In the Matter of
Long Island Lighting Company
(Shoreham Nuclear Power Station, Unit 1)
Docket No. 50-322-1 (OL)

List of Errata for Lilco's Testimony

I am enclosing a list of errata for Lilco's testimony on crankshafts, cylinder heads, pistons and cylinder blocks. In those instances where corrections are made to exhibits, a copy of the corrected exhibit is attached to this letter.

Strain vs. load for Gages 8, 9, and 10 (located on engine centerline).

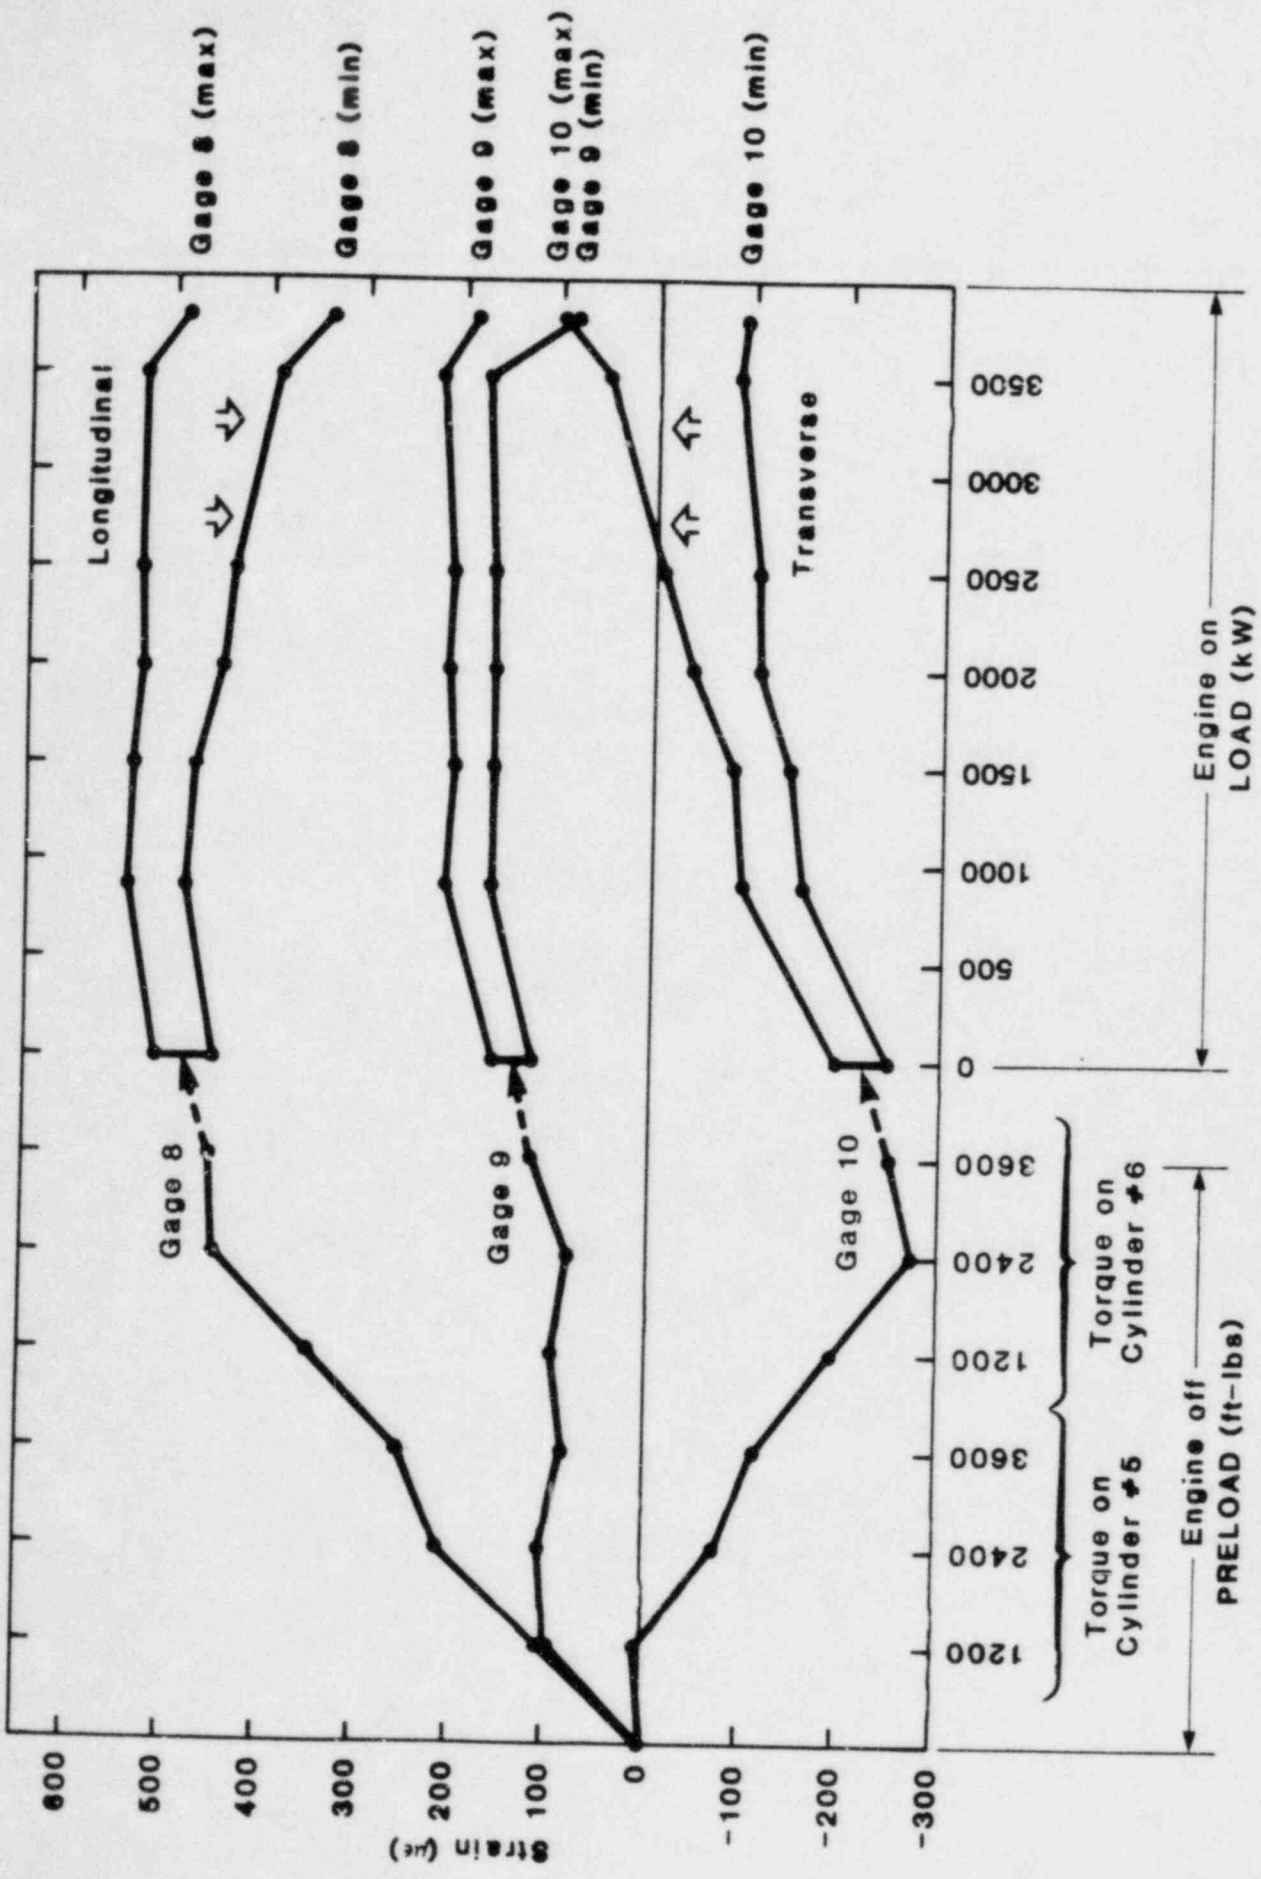
Exhibits B-13, B-14, B-15, B-26, B-49 and B-50 should be replaced with the corrected versions attached to this letter.
